# Sonoma County Planning Commission **STAFF REPORT**

**FILE:** DRH16-0006  
**DATE:** August 3, 2017  
**TIME:** 1:30 PM  
**STAFF:** Georgia McDaniel, Project Planner

**Appellant:** Valley of the Moon Alliance (VOTMA)  
**Applicant:** Flora Li for Tohigh Investment  
**Owner:** Tohigh Investment SF LLC (Tohigh)  
**Location:** 900, 1200, 1202, and 1204 Campagna Lane, Kenwood  
APNs: 051-260-014 Supervisorial District No.: 1  
**Subject:** Appeal of Design Review approval for a new Inn, Spa, and Restaurant  
**PROPOSAL:** Request for final Design Review approval for an inn, spa, and restaurant on a 51.9 acre parcel.

Uphold the October 19, 2016 Design Review Committee approval of the revised project design and site plan modifications with two minor changes required by the Open Space Conservation Easement.

**A** WESTERN PARKING - CONCEPTUAL LAYOUT  
SCALE: 1" = 40'

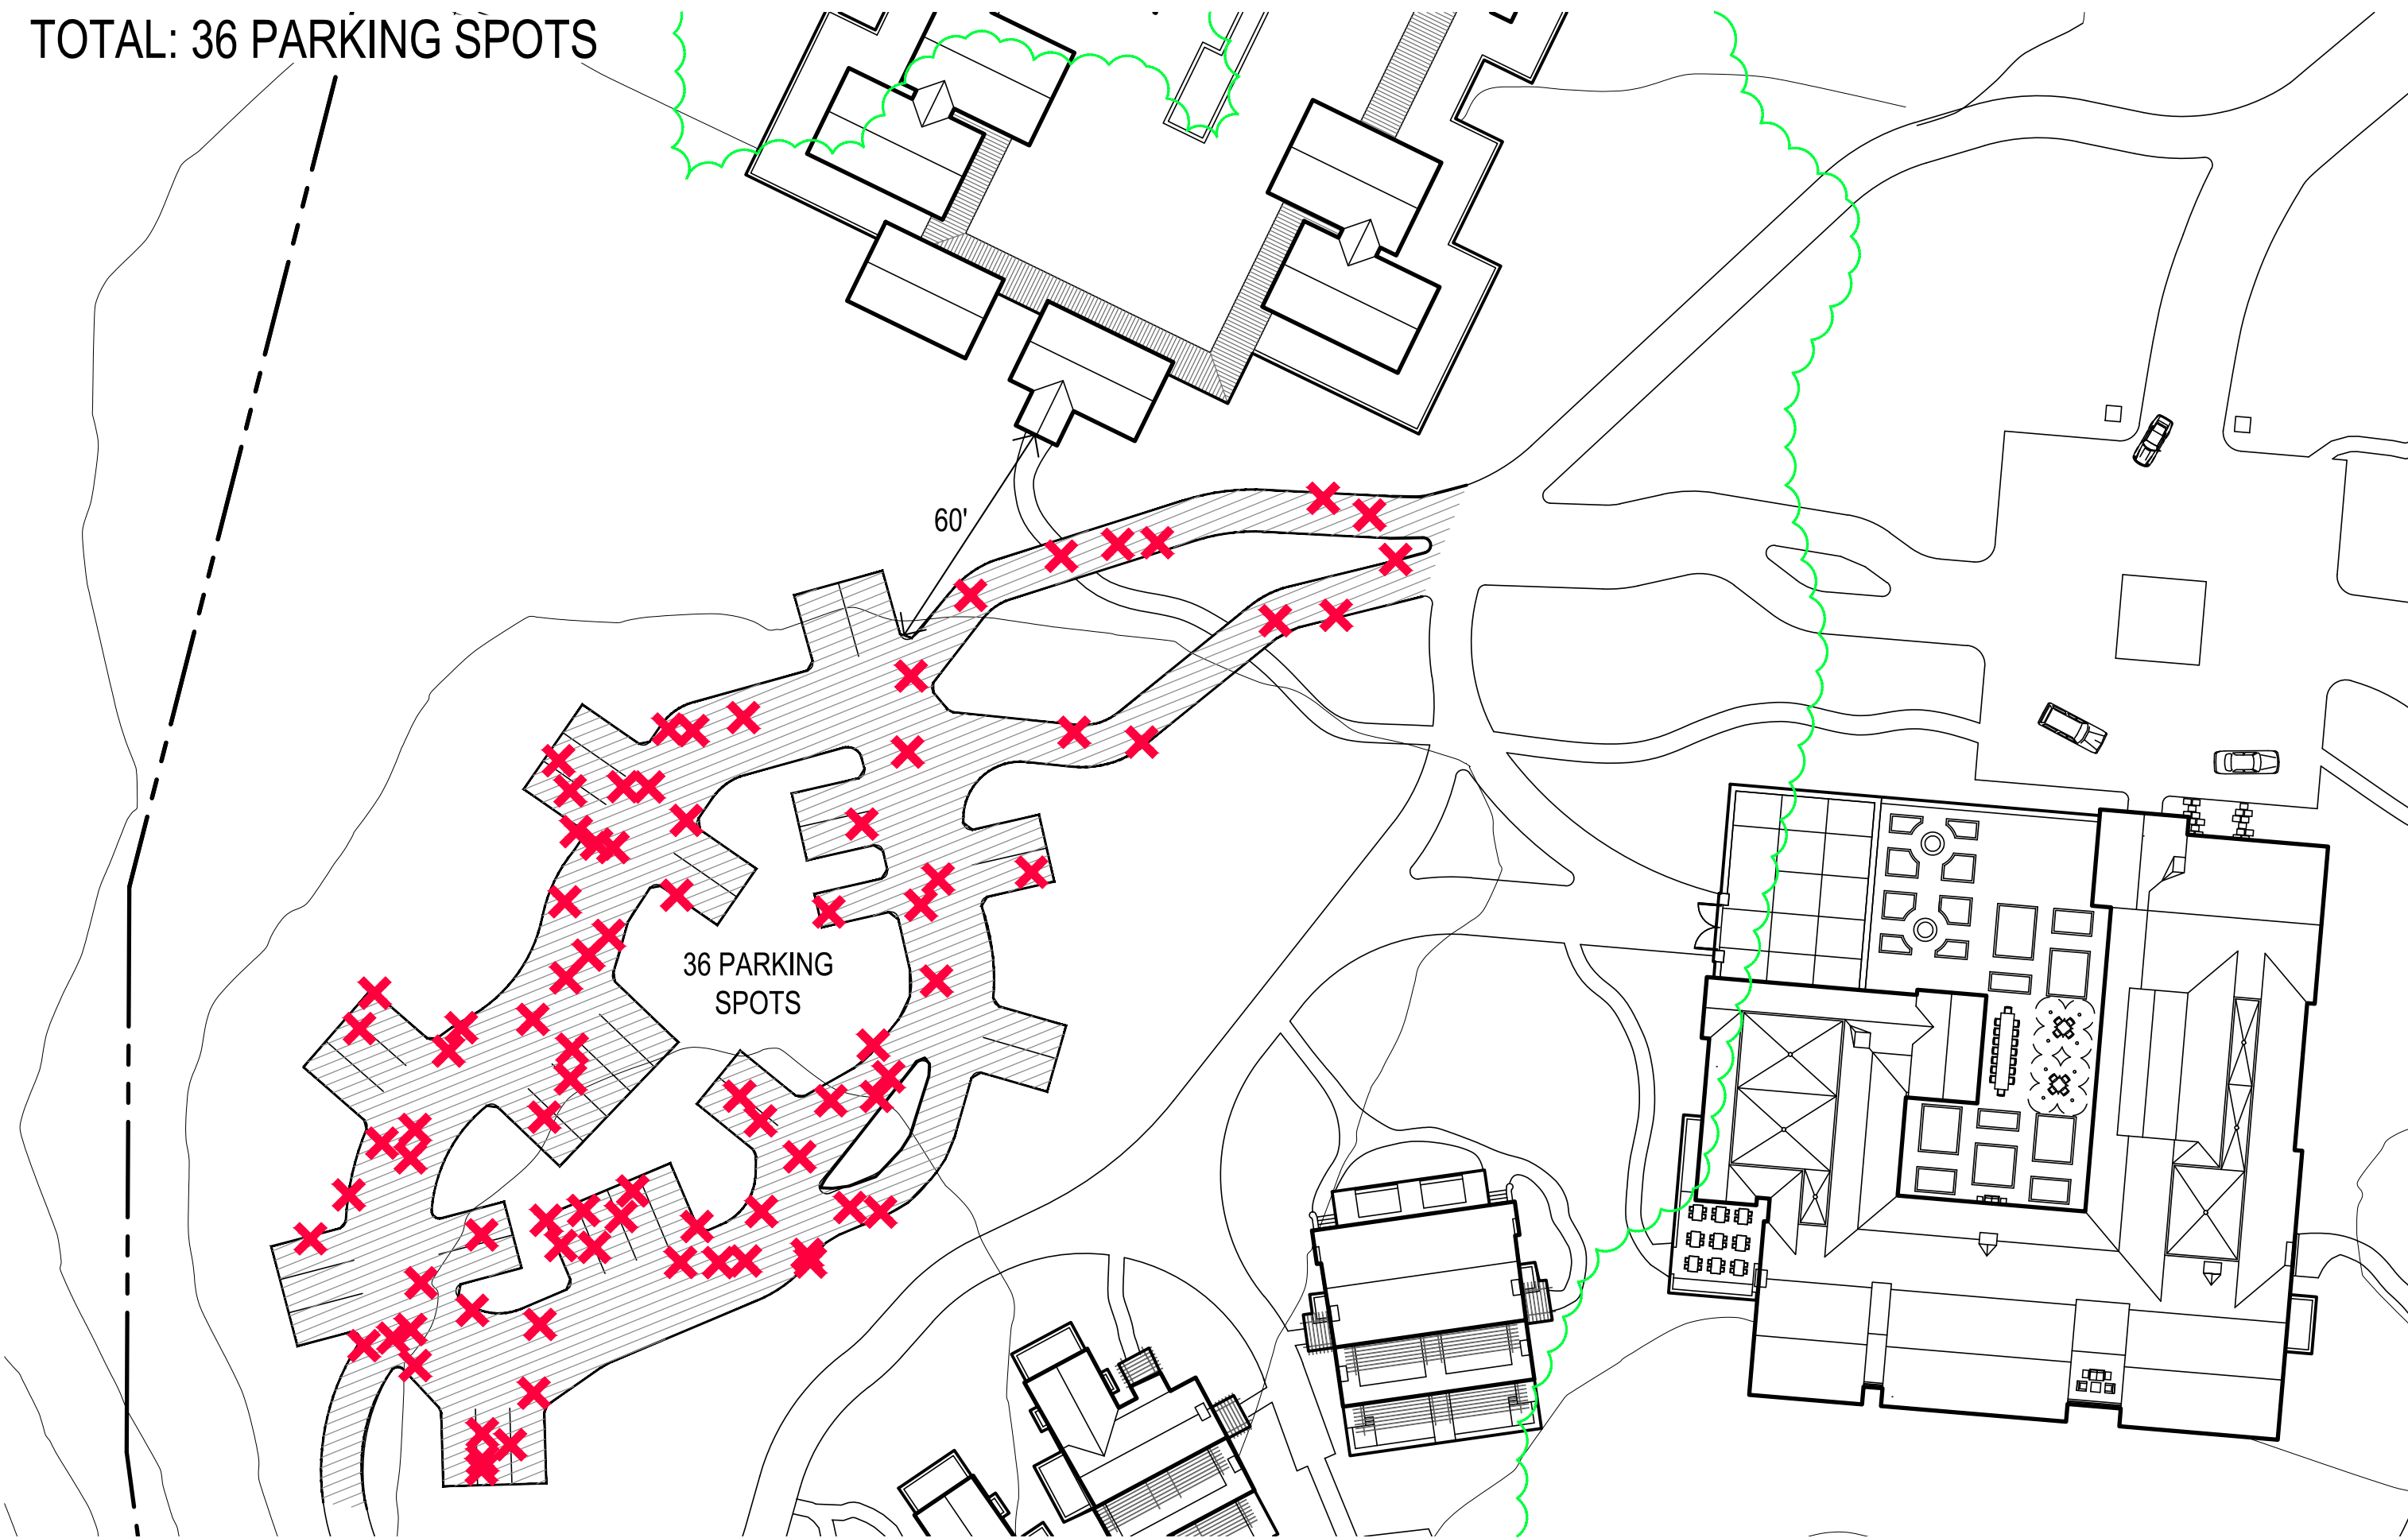
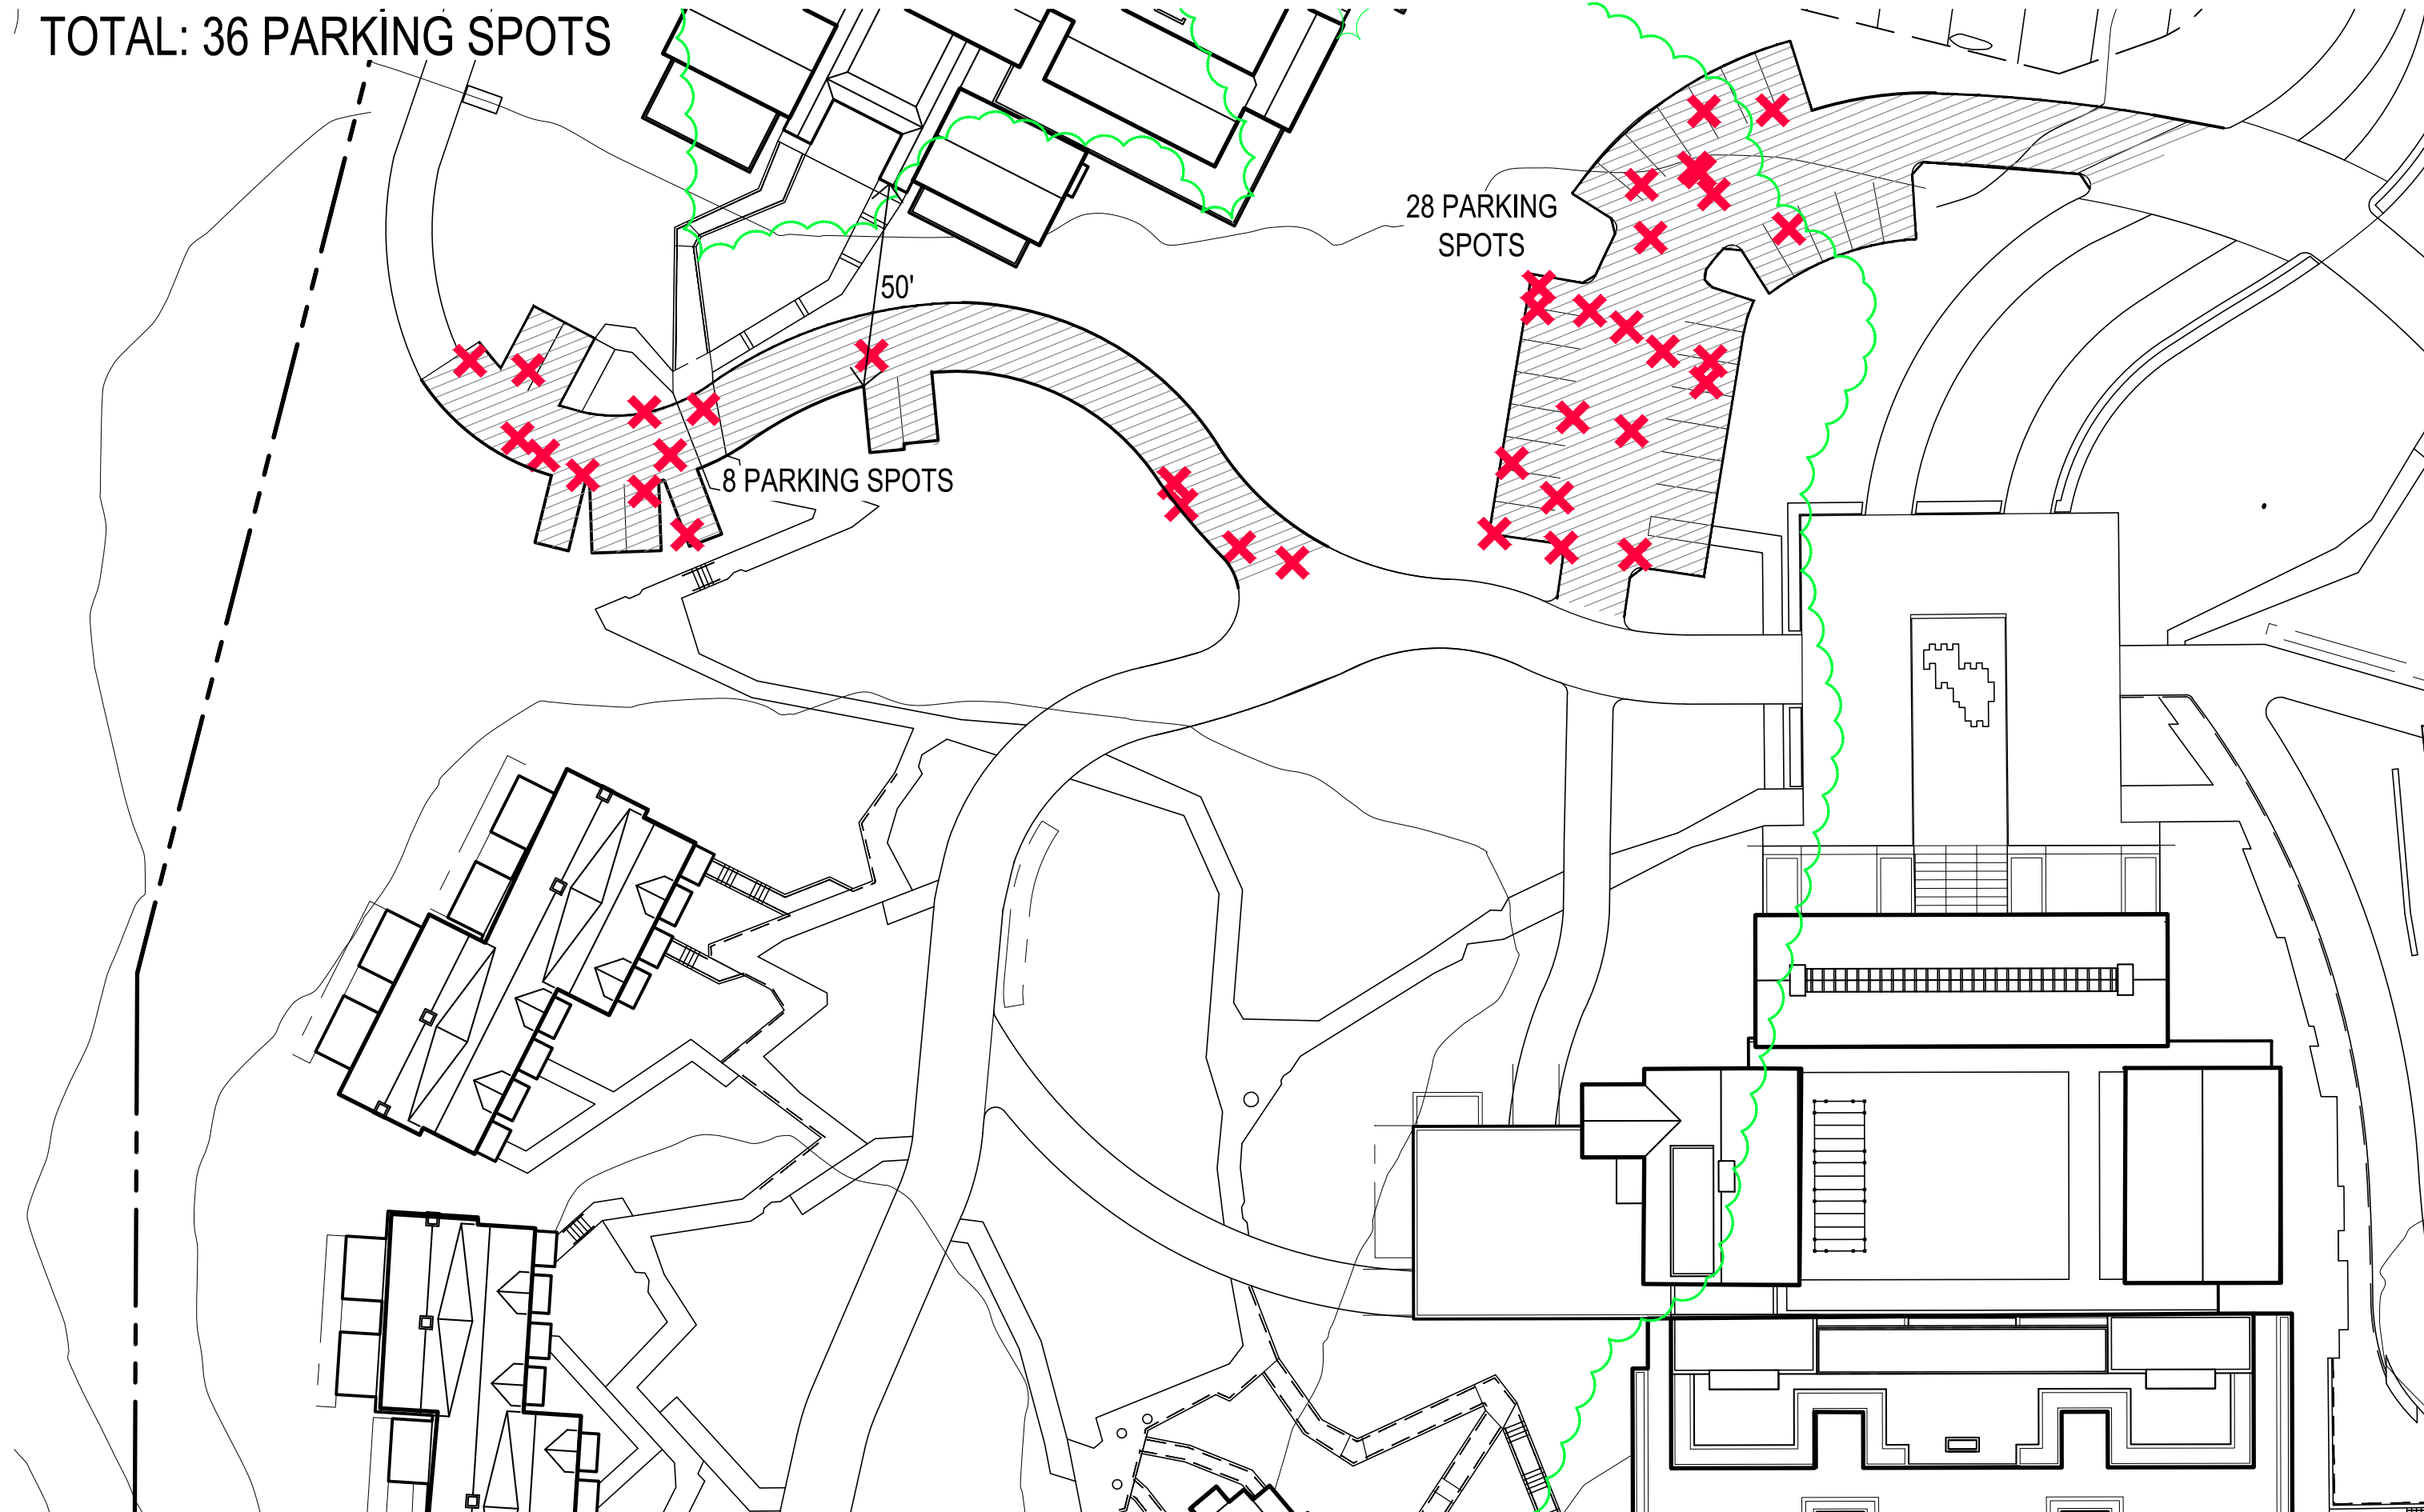
Appellant contends that aggregation of parking into two new 66- and 36 -space parking lots will create tree removal and habitat impacts and questions whether the Open Space District was consulted on the new layouts.

Changes to the western parking lot layout would require removal of 37 trees compared to 84 trees with the conceptual design. (BGK Summary of Impacts, Sheet 7.) The relocated eastern parking lot for the proposed design would remove 54 trees compared to 99 for the conceptual design. (BGK Summary of Impacts, Sheet 8.) Addition of the support building alongside the eastern parking lot would require removal of 13 trees not removed with the conceptual design. (BGK Summary of Impacts, Sheet 11.)
